Request for Information ("RFI")

Harrison, Town-Village Recrea
270 Harrison Avenue
Harrison, NY 10528

RFI No. 007

Regarding: SUMP PIT EJECTOR VENT

**DETAIL OF SUMP PUMP WITHIN SUMP
PIT, CONTROLS DIAGRAM AND POINTS LIST**
SCALE: NONE

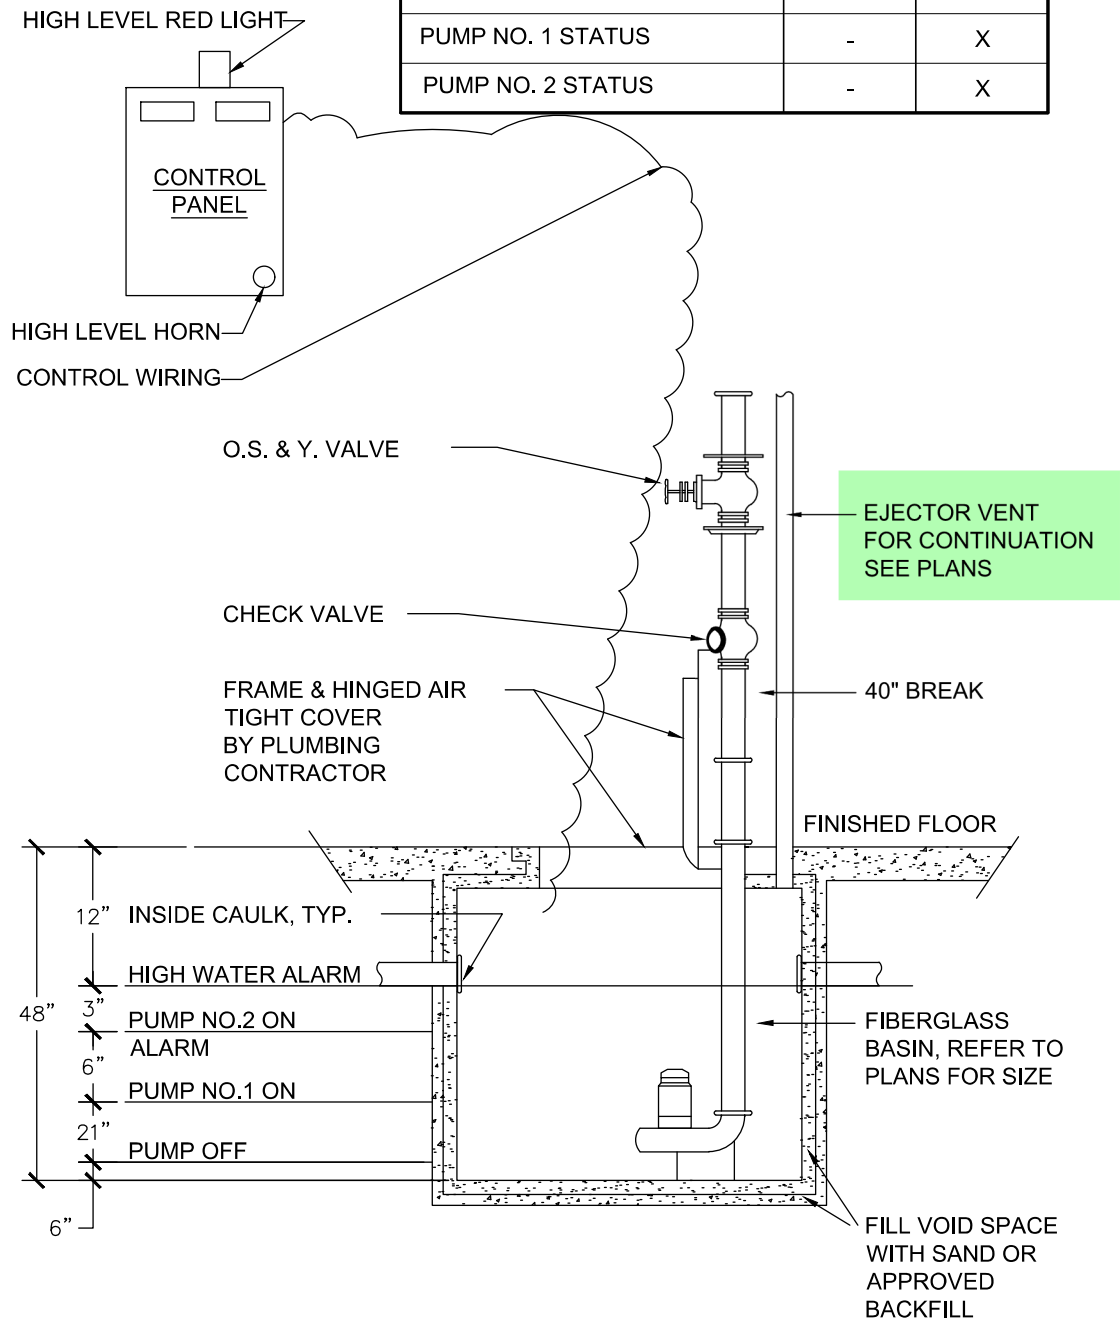
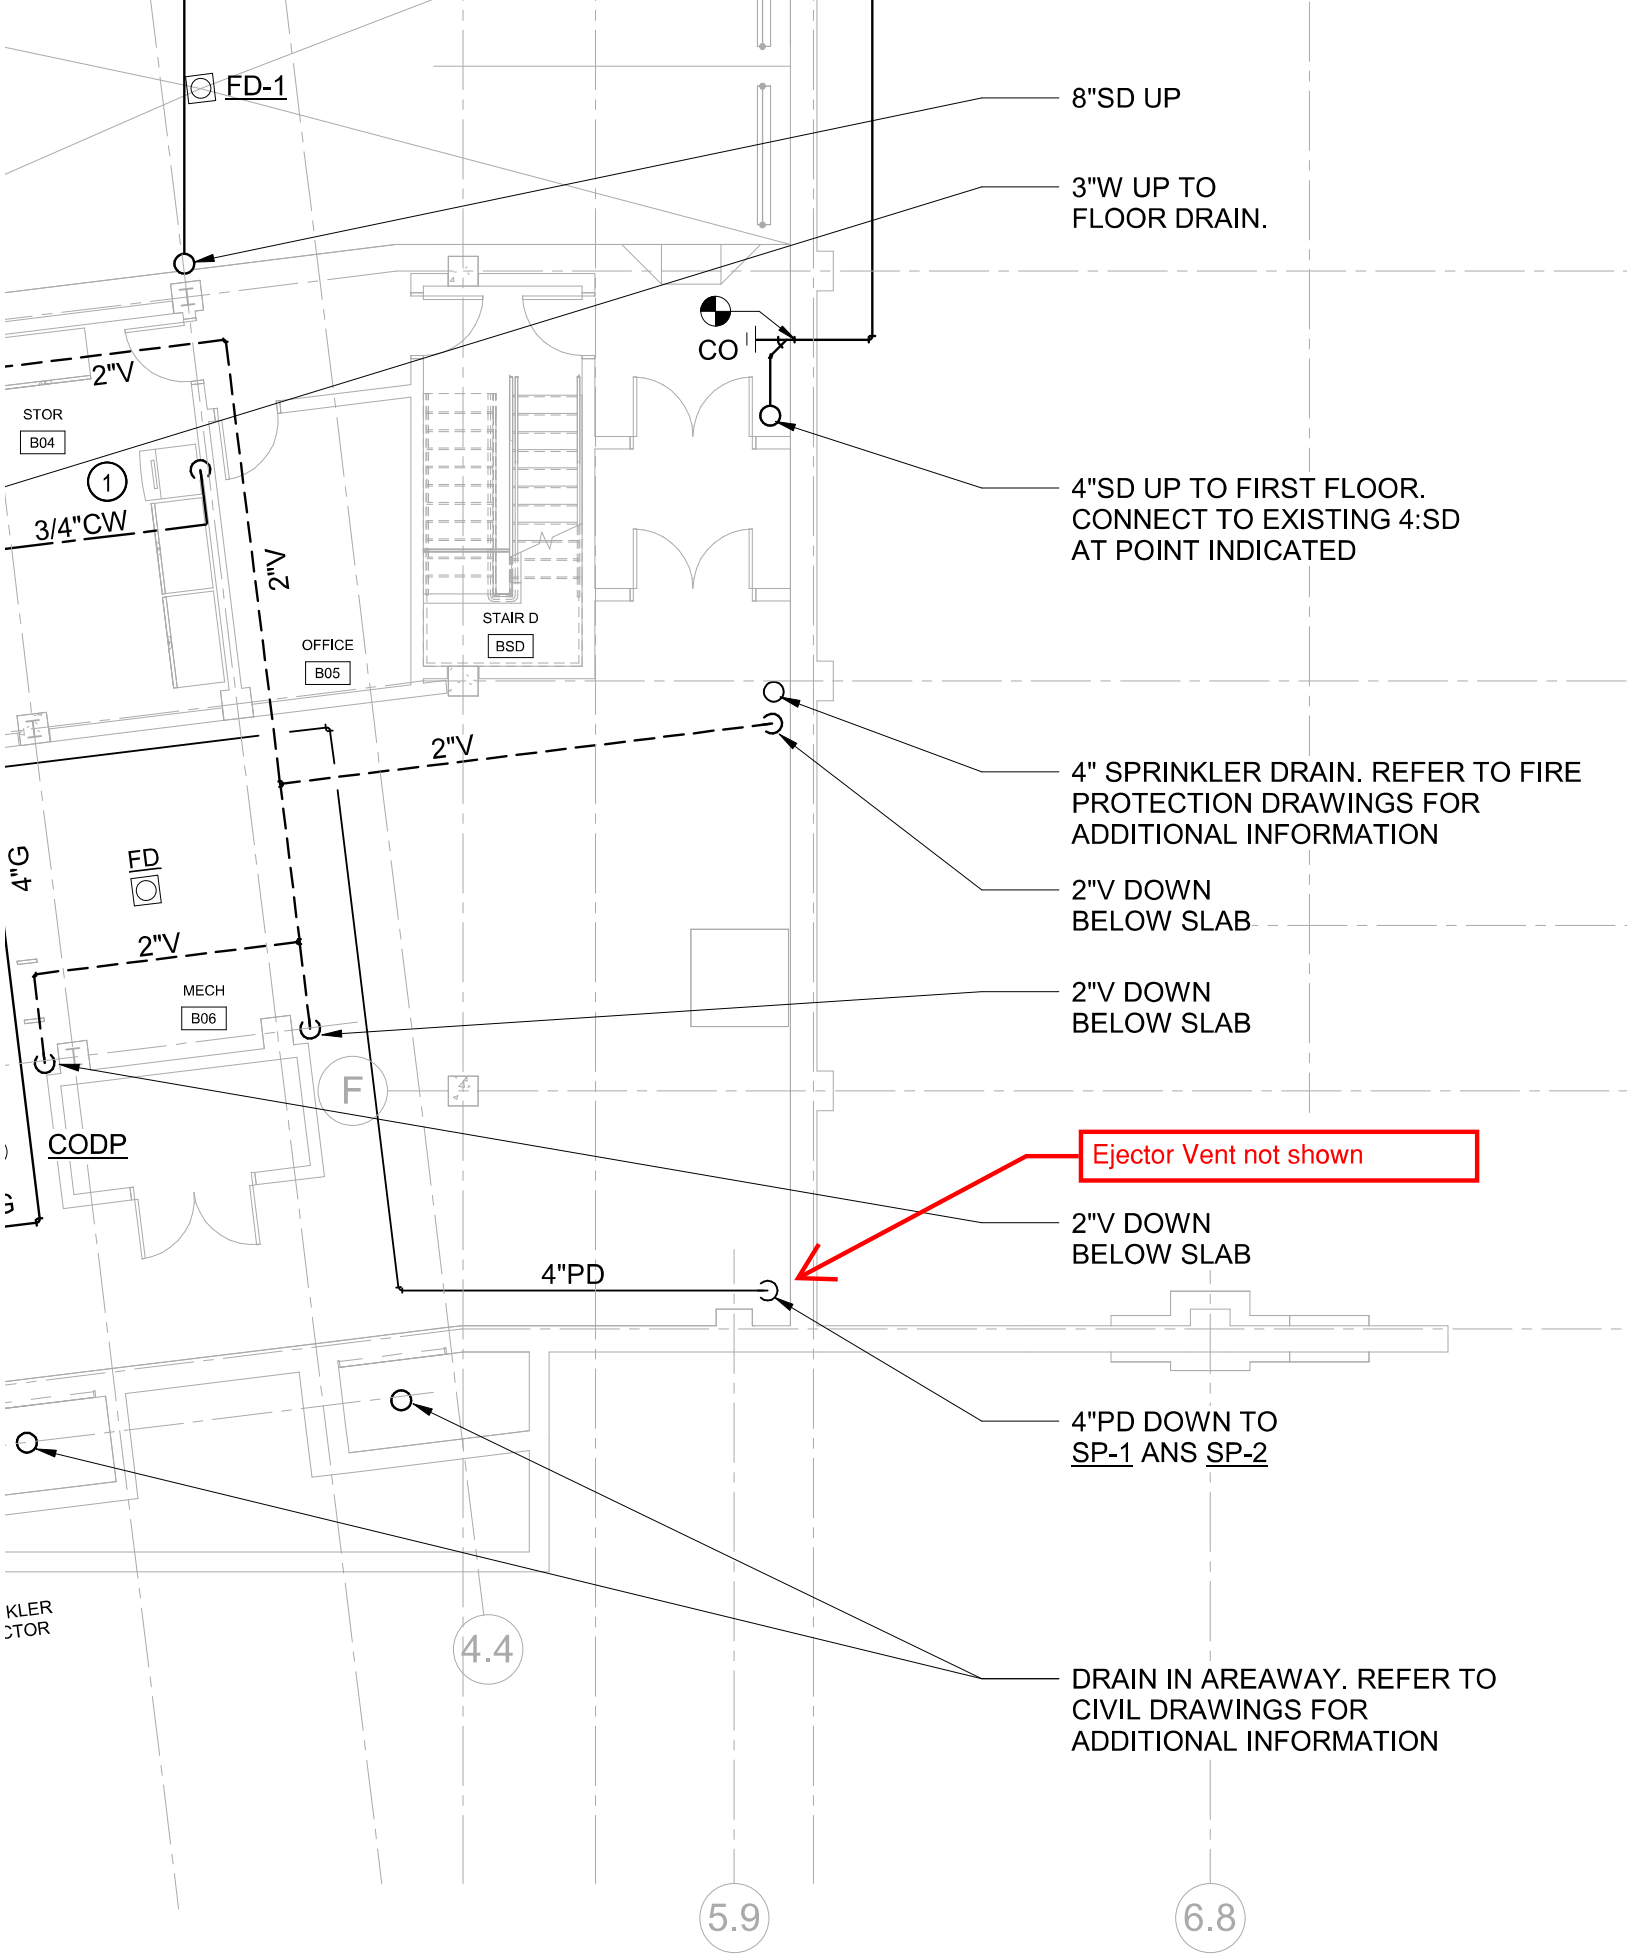
Detail 3 on P-702 calls for an ejector vent to be installed for the duplex sump pit, with a note directing us to see the plans for the continuation. No continuation for the vent is shown on the plumbing plans, please advise.

See response and marked up shop drawing below for the 3" vent route per OLA.

Provide 3"V for sump pump. Refer to page 4 four routing.
